City of Portsmouth Planning Board

Property Address: 161 Deer Street

Application #: LU-22-173

RE: Request for Site Plan Approval at 161 Deer Street to be known as 70 Maplewood Avenue, Mixed Use Site Development

EVERSOURCE EASEMENT REVISION
GRAPHIC SCALE

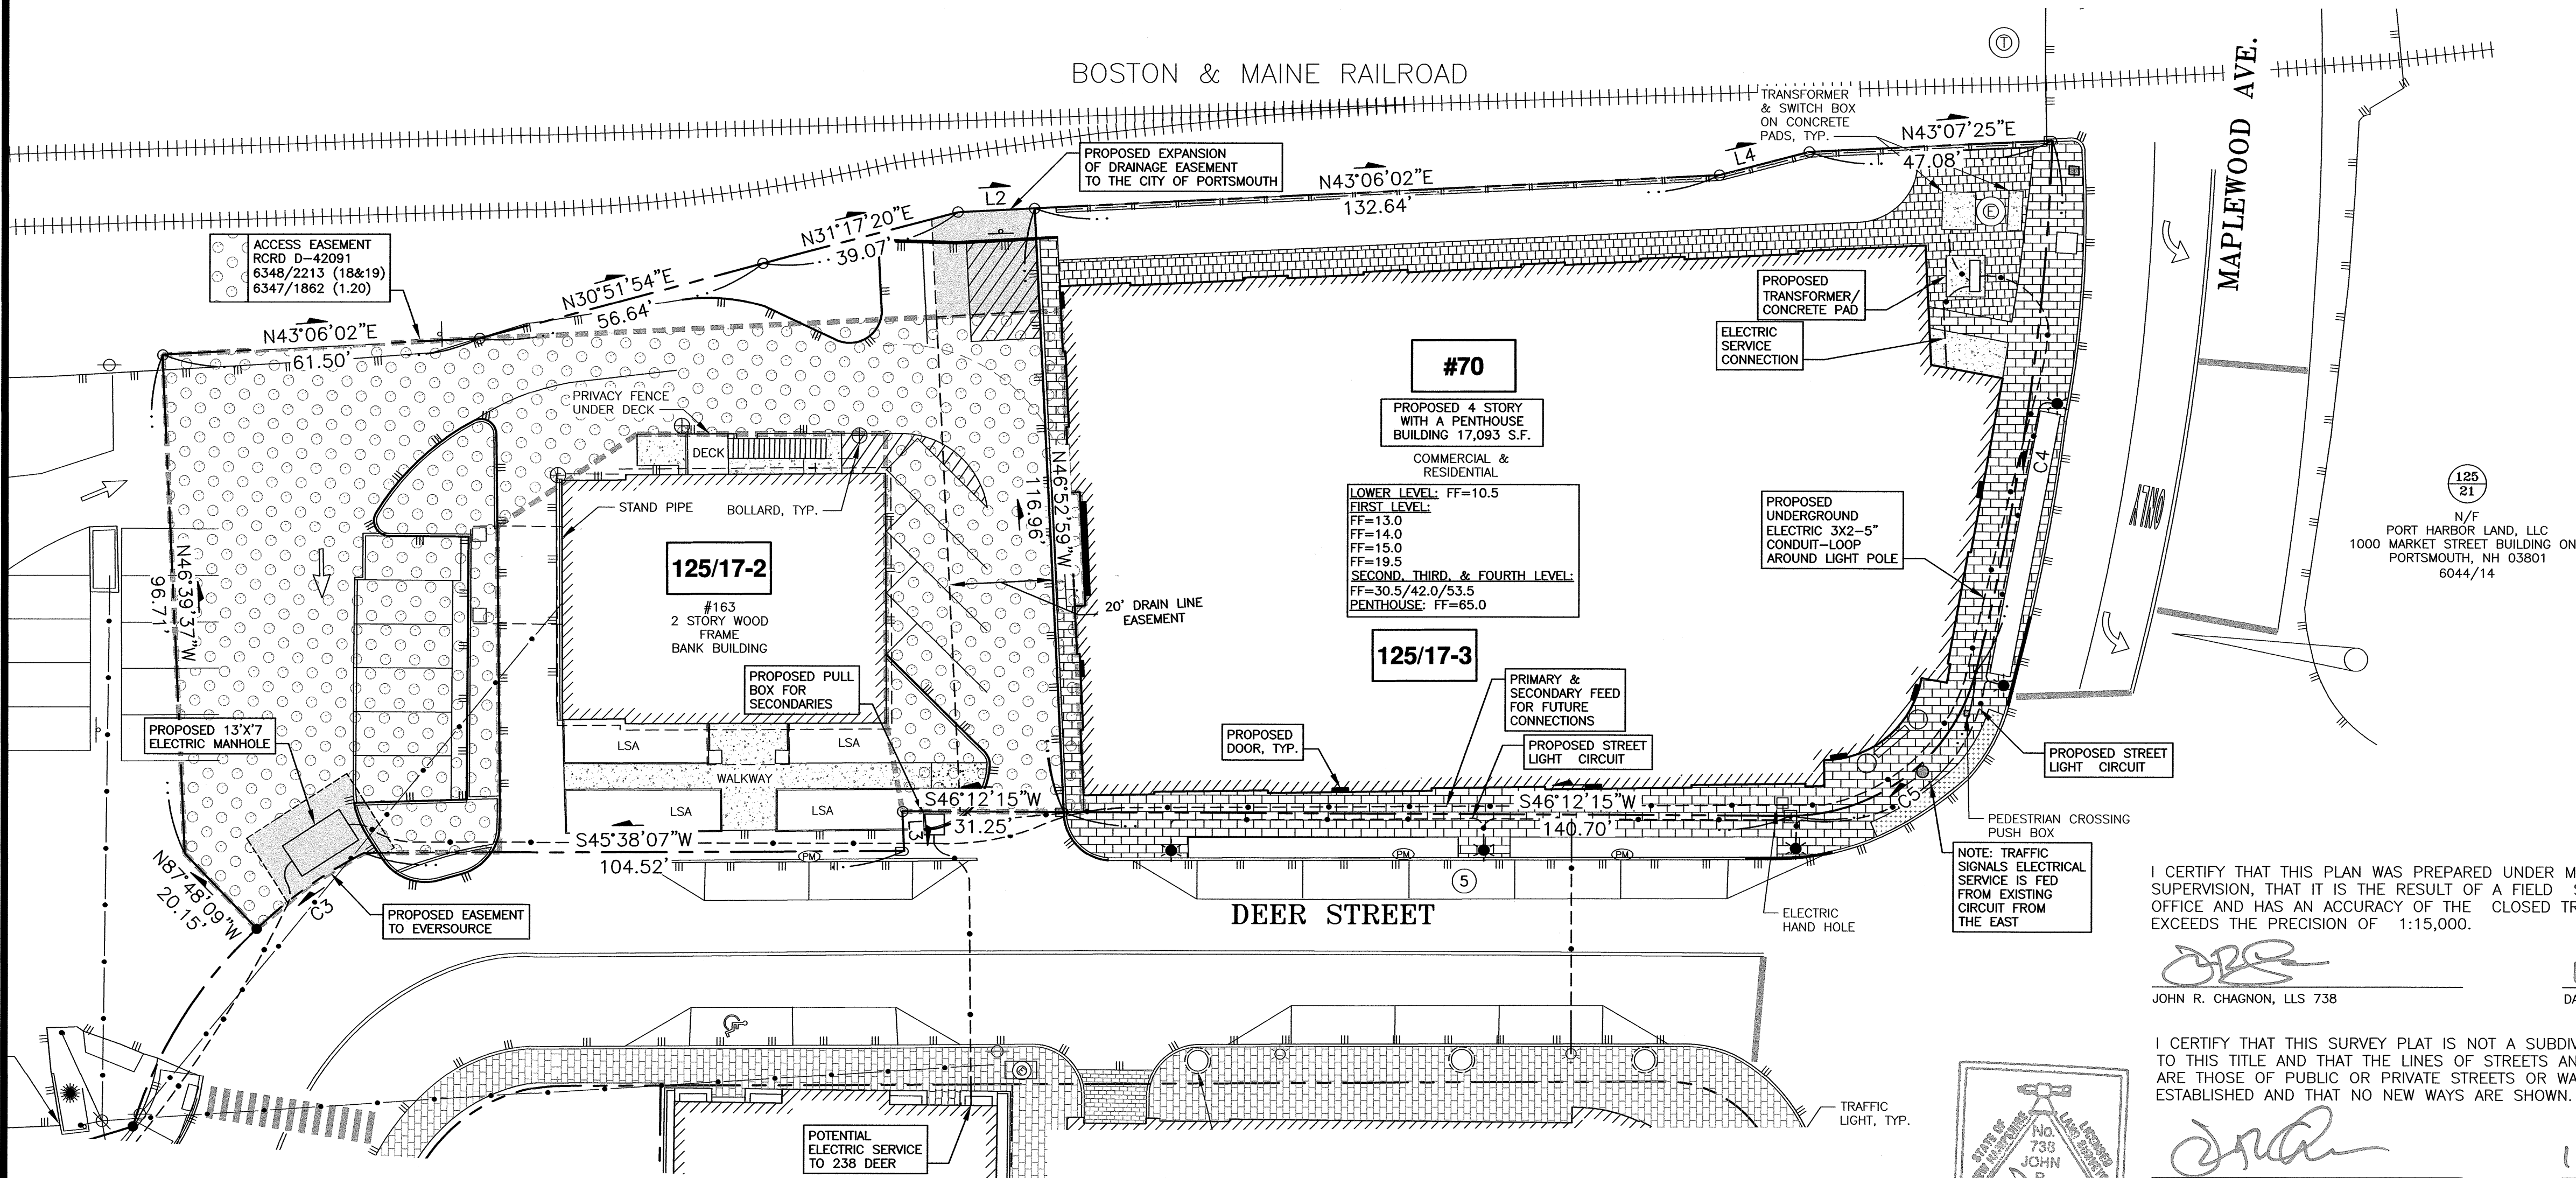
12. Applicant will update plans to include revised existing easement and proposed easement(s) with Eversource and will coordinate with the Department of Public Works to create a new easement around the drain line to the west of the building if needed. Applicant will also confirm how access rights are being provided across adjacent lot and provide an access easement if needed. **Access across the adjacent lot has been approved by the city – see the attached Site Plan C 3.0 for the Foundry Place Lot 3 Site Development.** If total number of easements equals 3 or more, applicant will provide an easement plan with unique identifiers and corresponding table. **An Easement Plan has been added to the plan set. The plan shows the following:**

- c. **Expanded Drainage Easement to the City of Portsmouth at the north end of the existing drainage easement.**
13. Applicant will update plans, related notes, and detail sheets to include a pedestrian and vehicle warning at the garage entrance to be reviewed and approved by Department of public works. **The plan set has been updated and specifications included in the submission.**
